Access Compliance Report

Public Rights-of-Way

(Pedestrian Signals)

Intersection ID: N/A	Main Street:	Cross Street: N/A	Location: N/A
ADA ID: 7DAF3F886E9E	Signal Type: One Push Button-APS	Overall Compliance: No	Severity Score: BTN 1: N/A BTN 2: N/A No BTN: N/A
Codes/Mitigation Info/Possible Solution		Field Measurements/Component Compliance

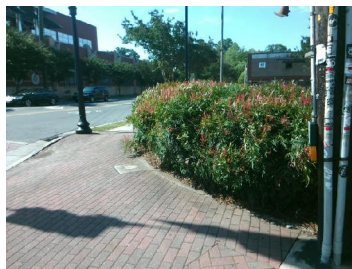
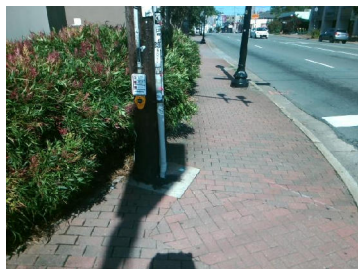
Surveyor Notes: TEXT HT 3/8

PROW/ADA: R410.6, TMUTCD 4e.08, R404.2, R404.3, R209.1, MUTCD 4e.10

Yes	B 1 Clear Xing Direction?	ClearlyMarked	N/A	B 2 Clear Xing Direction?	N/A
	B 1 Crossing Direction	To N		B 2 Crossing Direction	N/A
Yes	B 1 DistanceTo XWalk (in)	0.0	N/A	B 2 DistanceTo XWalk (in)	N/A
No	B 1 DistanceTo Curb (in)	93.0	N/A	B 2 DistanceTo Curb (in)	N/A
Yes	B 1 Diameter (in)	2.0	N/A	B 2 Diameter (in)	N/A

Possible Solutions: Replace Signal Push Button With APS Button on New Post. Remove & Replace Sign.
